RE: 17 Locust St
Zone R1.03

PLOT AND GRADING PLAN
17 LOCUST STREET
TAX LOT 27.04 BLOCK 101
 BOROUGH OF HIGHLANDS
 MONMOUTH COUNTY, NEW JERSEY

**Re: Catcherman, LLC
17 Locust Street
Block 101, Lot 27.04
Single Family Residential (R-1.03) Zone
First Completeness Review**

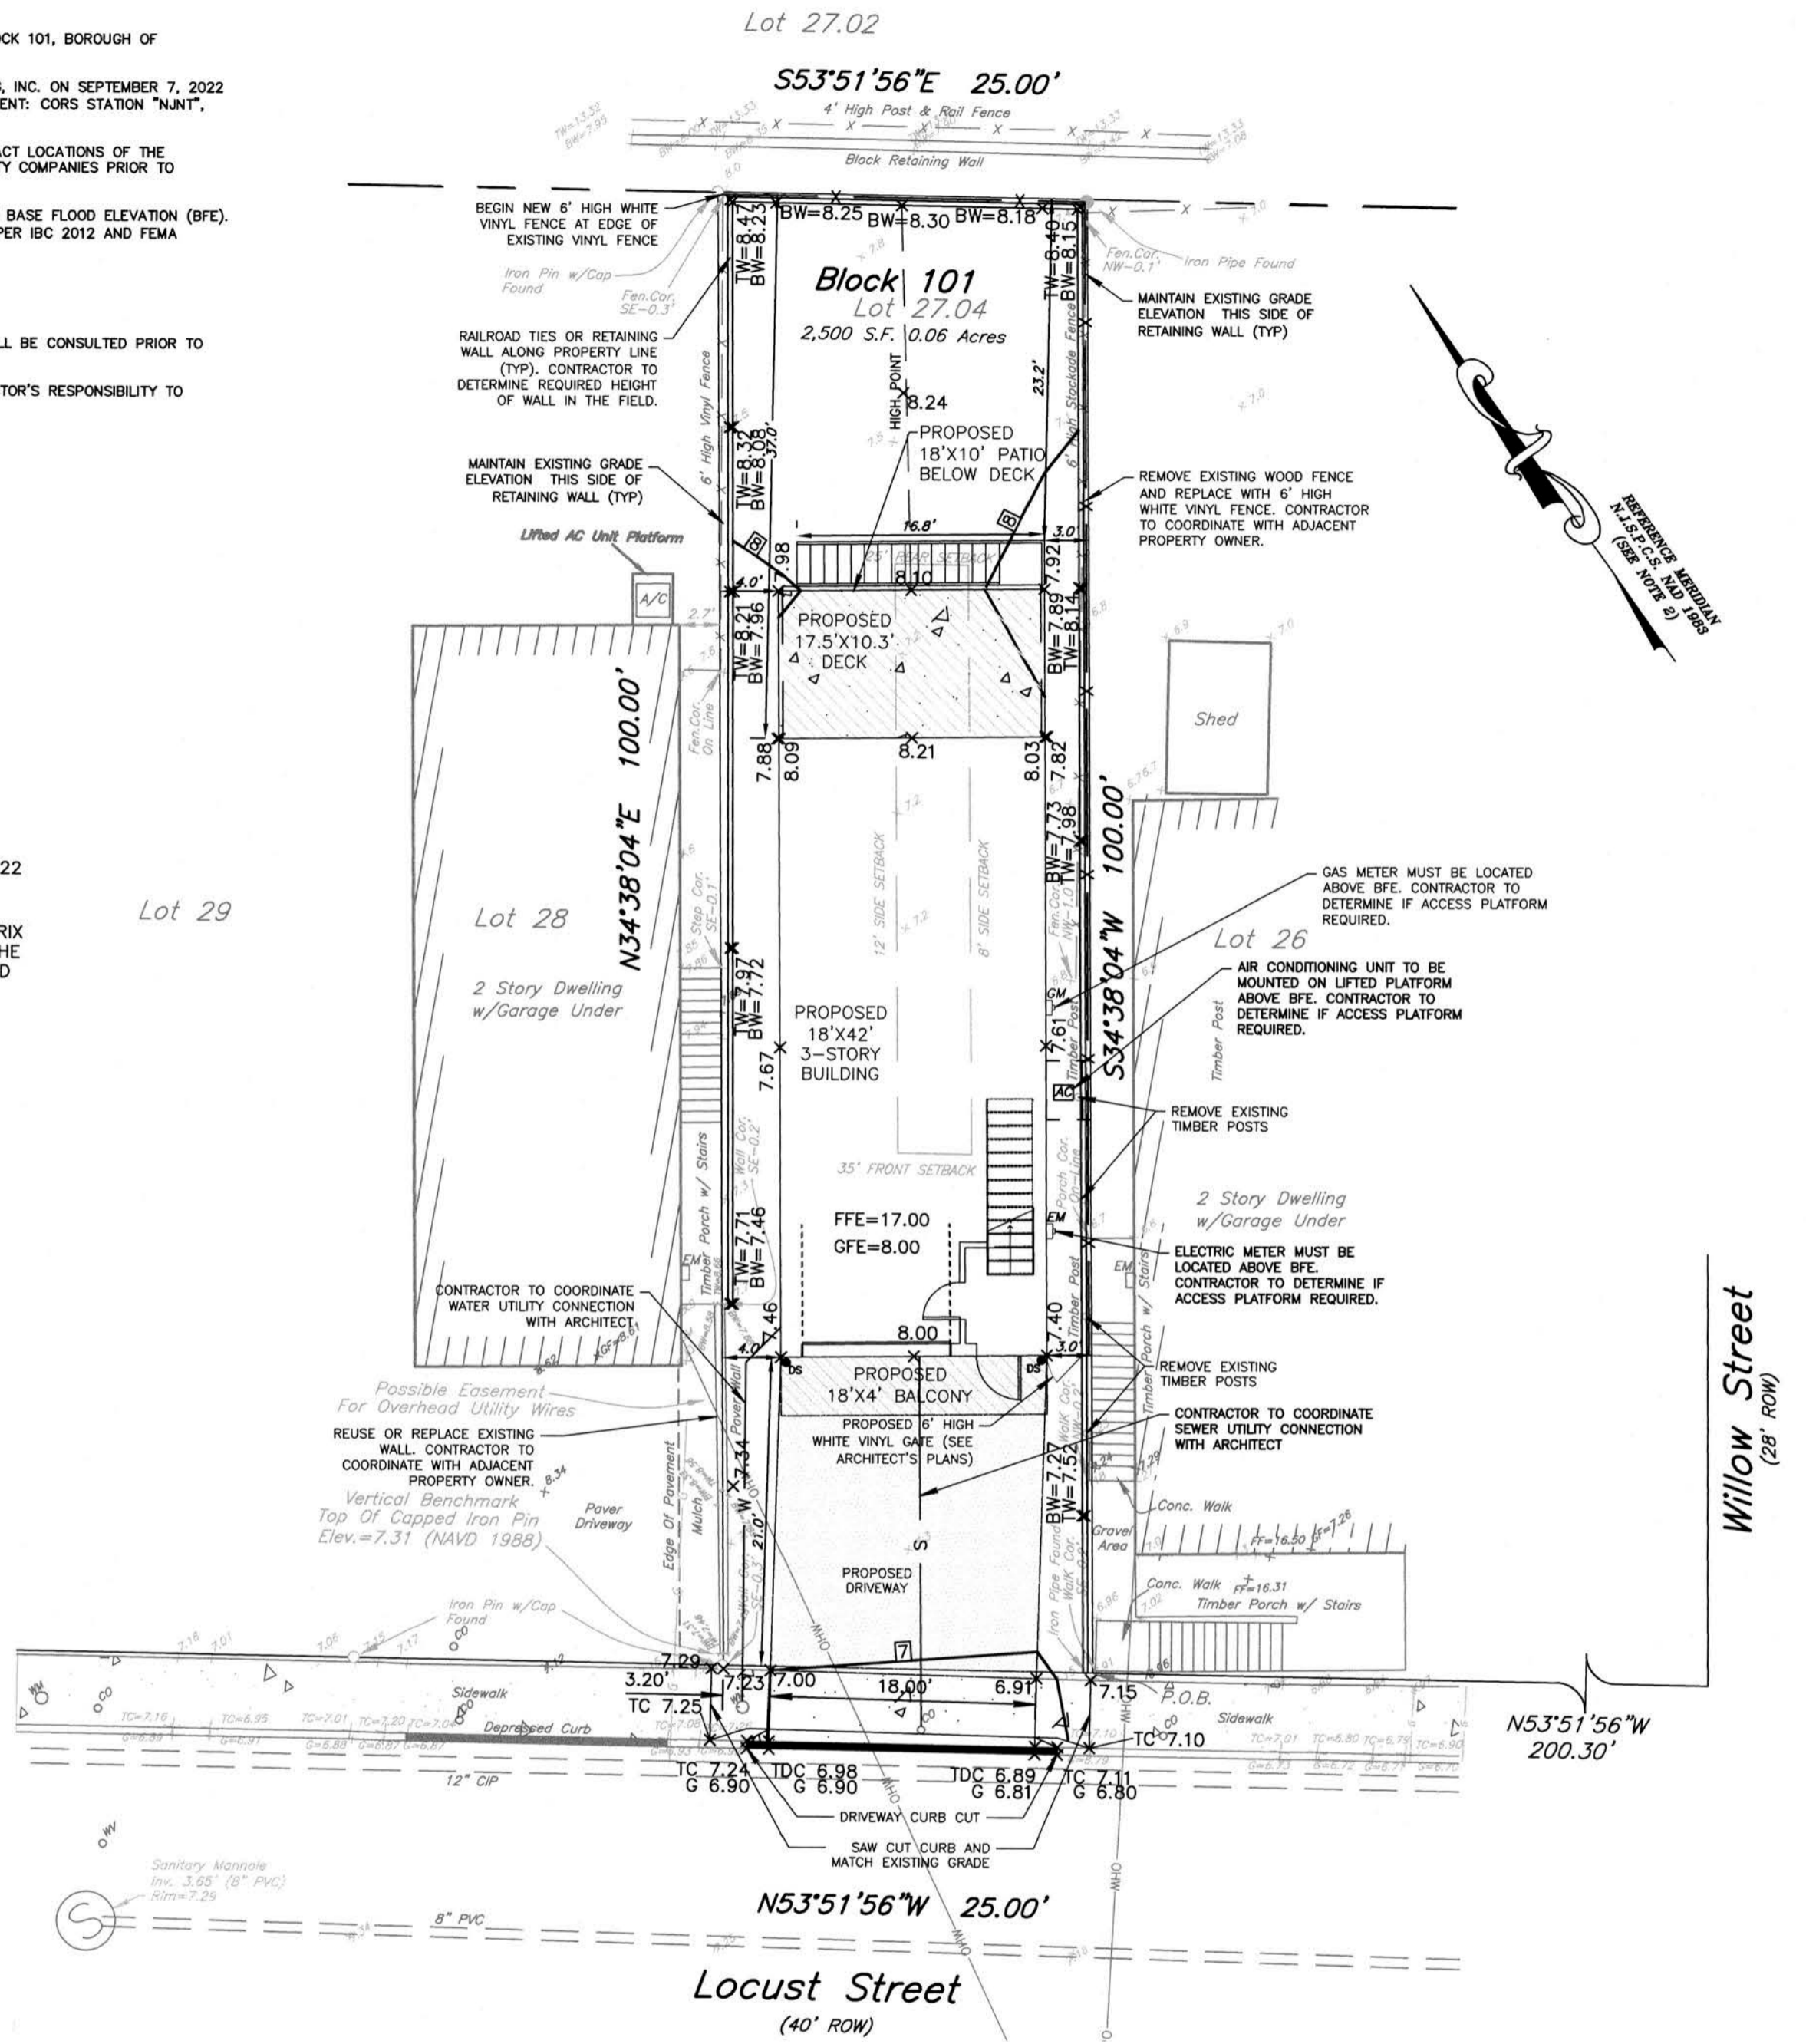
7. Specifications for and location of proposed surface paving and curbing. **Partially Provided. Specifications & details for paving and curbing are not shown on plan.**

8. Location of all structures within seventy-five (75) feet of the property. **Partially provided.**
9. Location of off-street parking areas, with dimensions, showing proposed parking and loading spaces, with dimensions, width of proposed access drives and aisles and traffic circulation. **Provided.**

11. Existing and proposed contours of the property and for seventy-five (75) feet outside the property at one (1) foot intervals when new buildings or parking areas are proposed. Spot elevations for any development in a flood hazard area. **Partially provided.**

2. There is a discrepancy in the building height shown on the plot plan and the architectural plans. The applicant shall revise the plans to clarify. The correct building height as defined by Borough Ordinances for dwellings in the flood zone shall be included on the Plot Plan zoning schedule as well as the Architectural Plan. The basis of measurement should be the grade plane, defined as the Base Flood Elevation plus one foot, or elevation 13.0 in this case.

2. The applicant shall provide a breakdown table for building and lot coverage calculations.
3. The applicant shall review the proposed grading on the eastern property line. The bottom of wall elevations (exterior side of the property lines) should be consistent with existing grading along Lot 26.

7. The applicant shall indicate downspout locations on the plan.
8. Although this project is not considered a major development. The improvements increase impervious coverage by approximately 1,125 square feet. The applicant shall provide testimony on any adverse drainage impacts to the adjacent properties as a result of the proposed improvements.

7. *Specifications for and location of proposed surface paving and curbing...*
The plot plan has been revised to include details for the proposed paving and curbing.

8. *Location of all structures within seventy-five (75) feet of the property...*
The plot plan has been revised to include the location of all structures within seventy-five feet of the property.

11. *Existing and proposed contours of the property and for seventy-five (75) feet outside the property at one (1) foot intervals...*
The plot plan has been revised to include the requested information.

GROUND AND FIRST
FLOOR CONSTRUCTION
PLANS

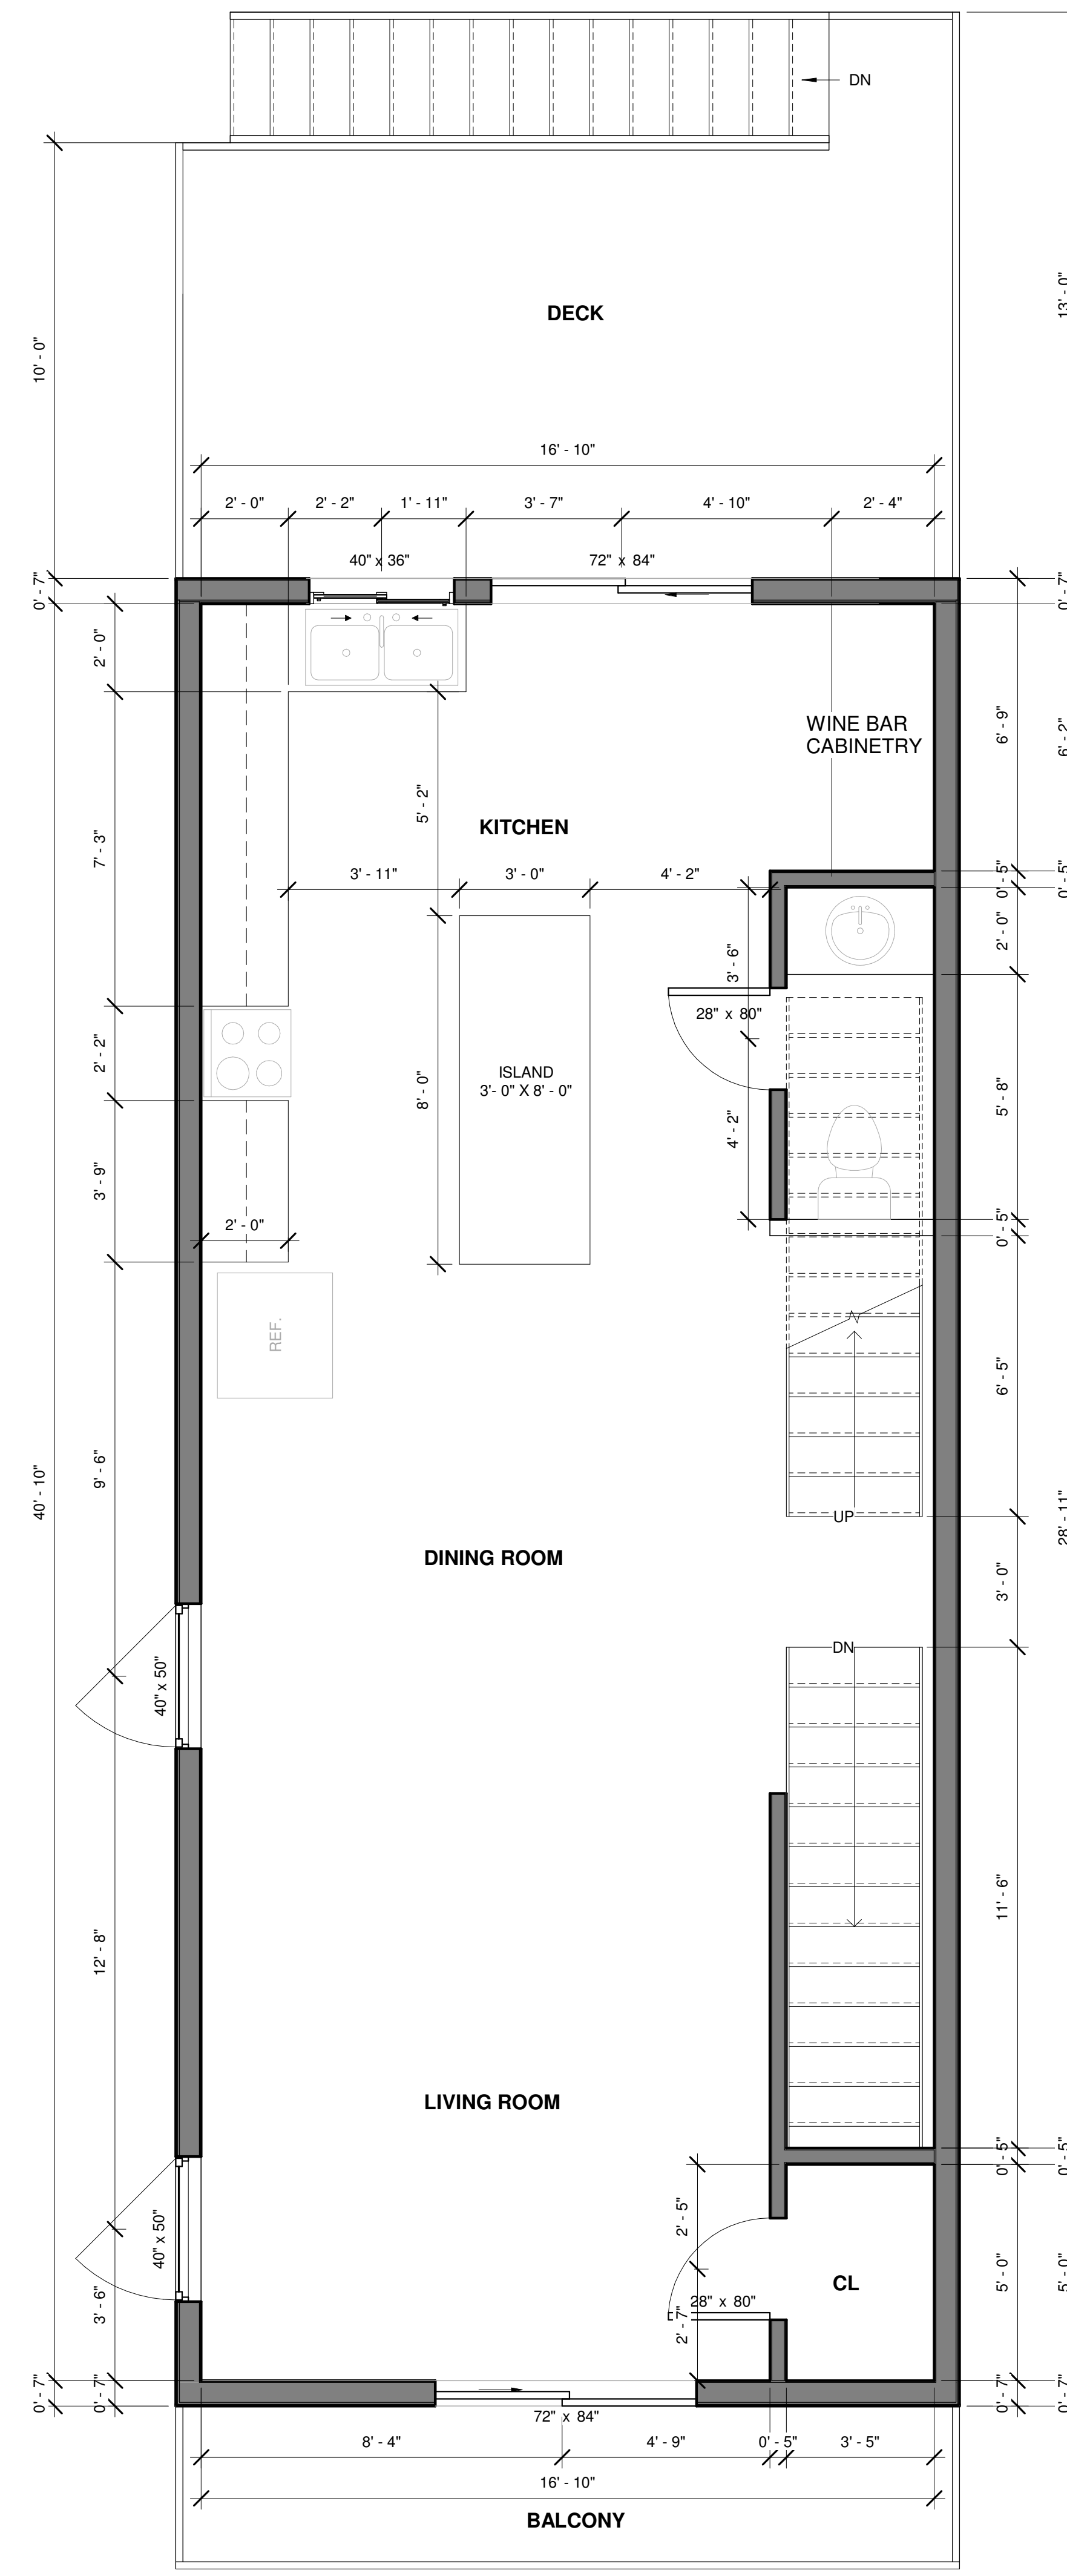
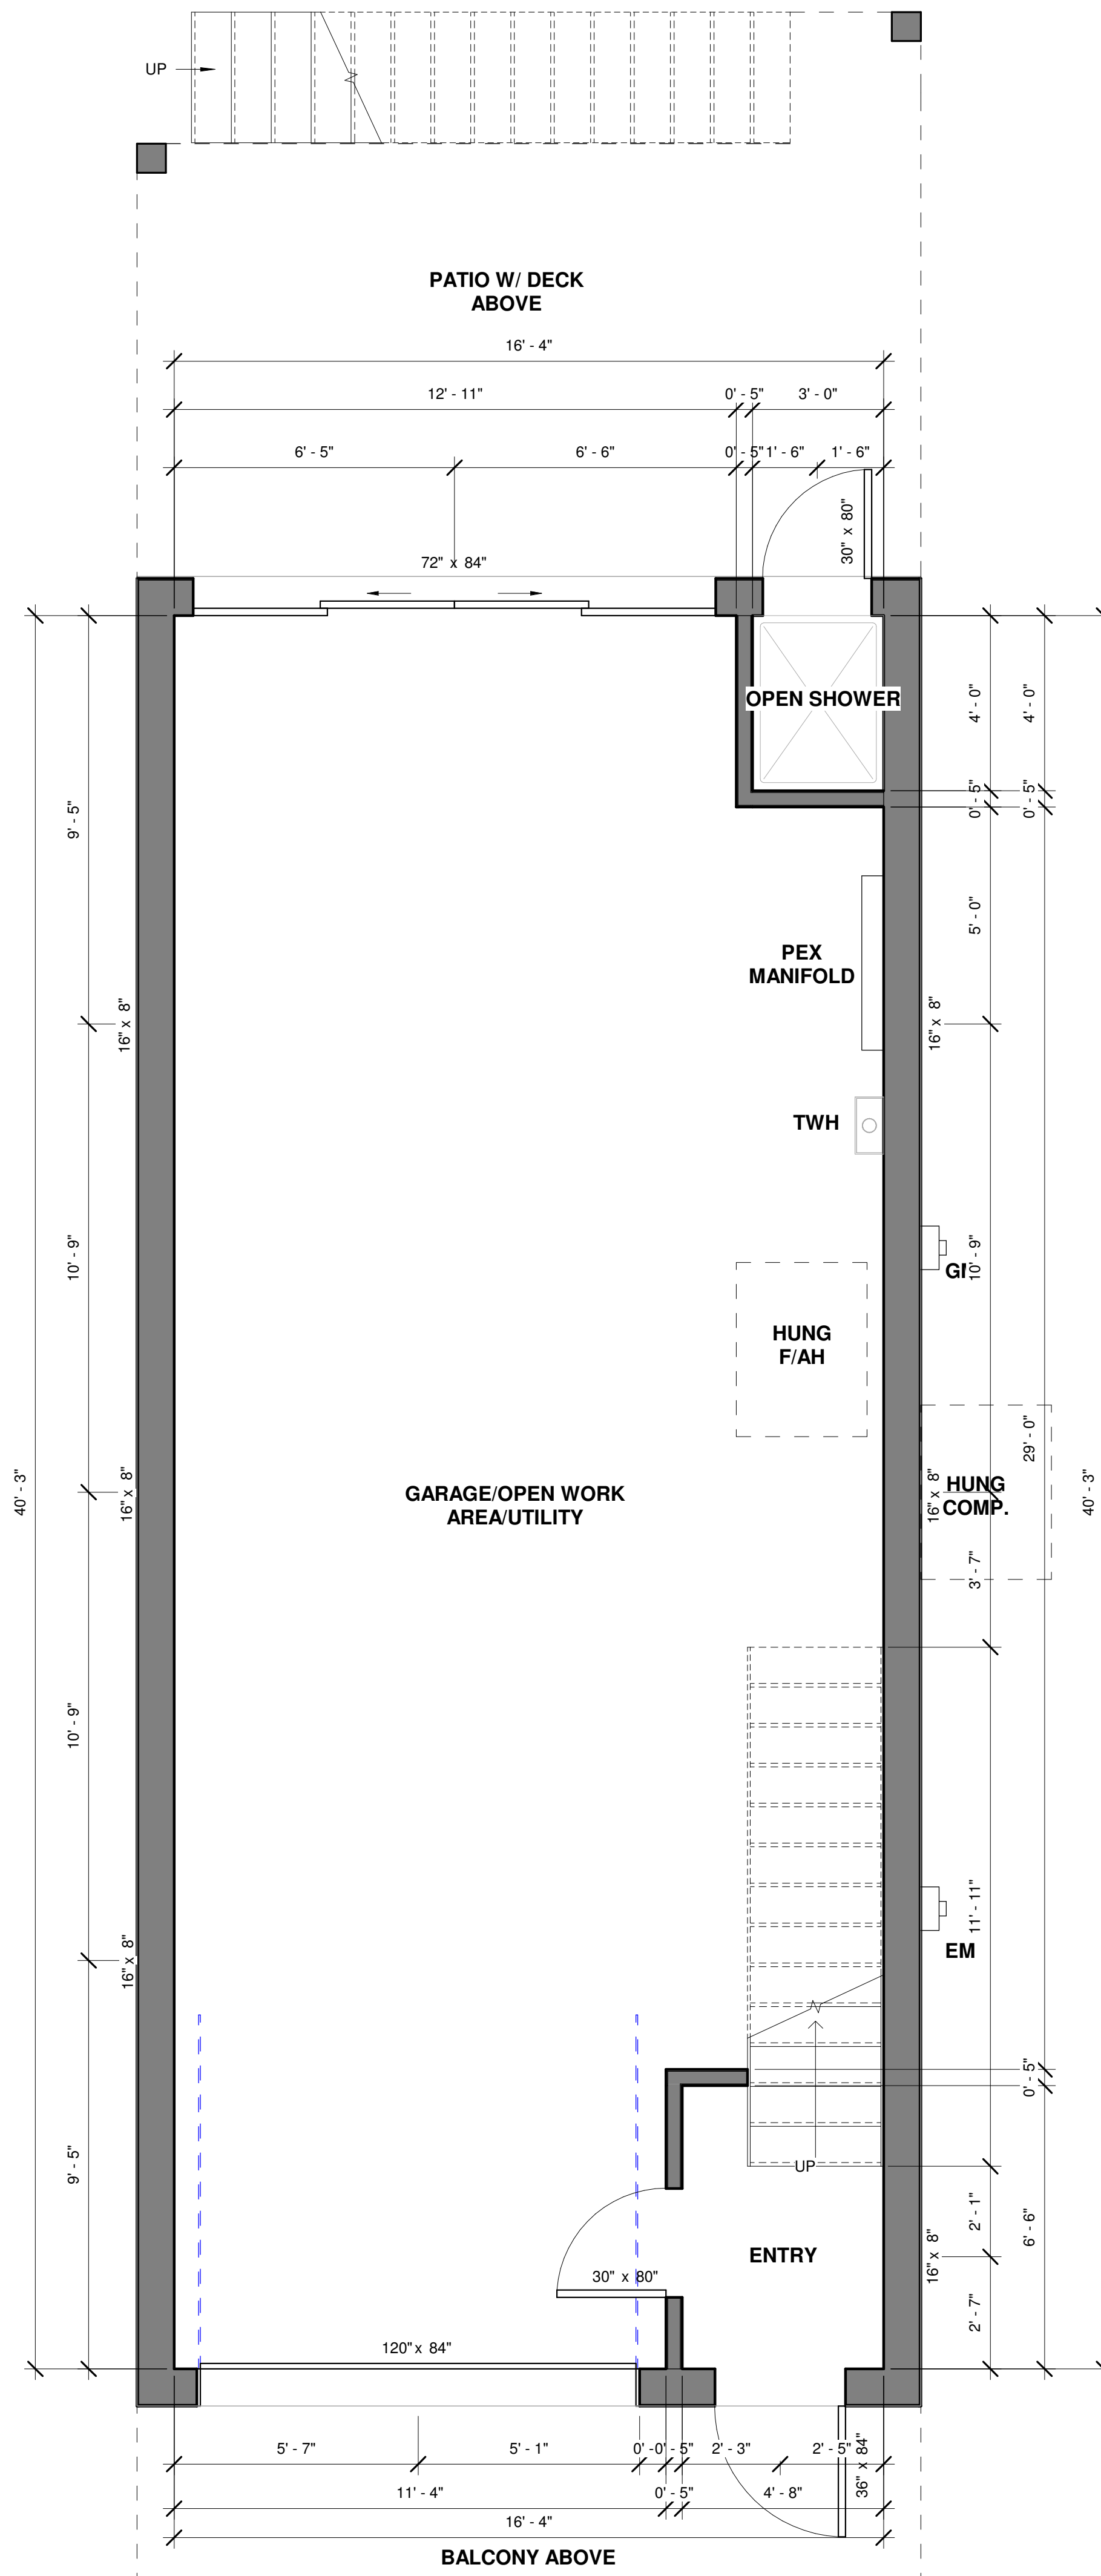
18. Preliminary architectural plans for the proposed buildings or structures indicating typical floor plans, elevations, heights and general design or architectural styling. **Provided. Please note that as the electrical & gas meters are proposed 6 feet above grade to the bottom of the meters, utility**

providers may require a platform to be installed, which may not fit in the proposed side yards and would require additional variance in the side yard. It appears there may be sufficient elevation to lower the meter below the platform requirement height and still be above the BFE. Additionally, the correct building height as defined by Borough Ordinances for dwellings in the flood zone shall be included on the Plot Plan & Architectural Plan prior to the board hearing.
